Oil Filter Housing
MP8 US2010, US2014
CHU, CXU, GU, MRU

FSB 222-004, Oil Filter Housing

(January 2016)

W2059284

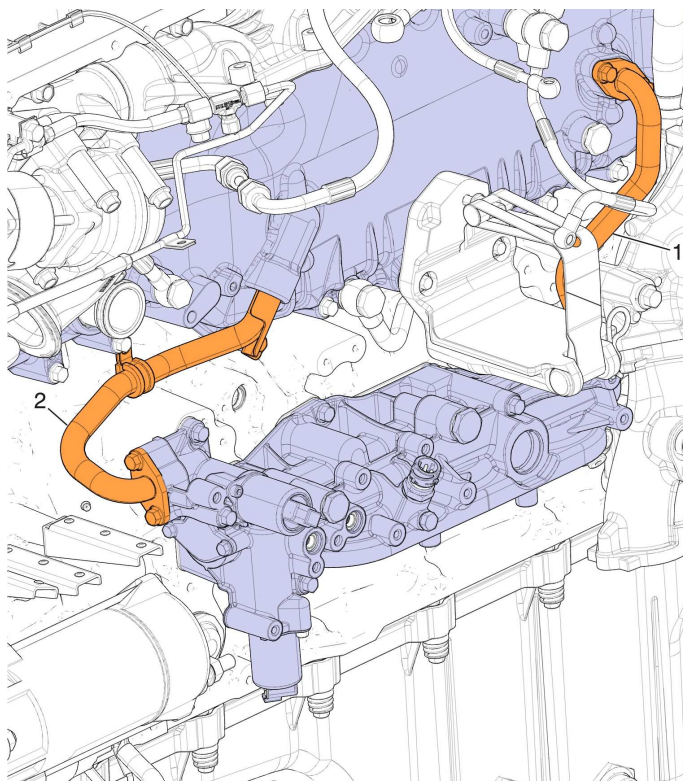
The introduction of a new style oil filter housing requires replacement of the oil cooler inlet pipe when replacing the previous style housing on US2010 and US2014 emission MACK MP8 engines with an engine serial number less than 1125655. Installation procedures remain the same, refer to Function Group 22 in Impact for proper installation. The updated oil filter housing went into production September 2015.

Previous Housing Part Numbers	New Style Housing Part Number	Pipe Part Number
21811042, 22095768	22108170	22026543
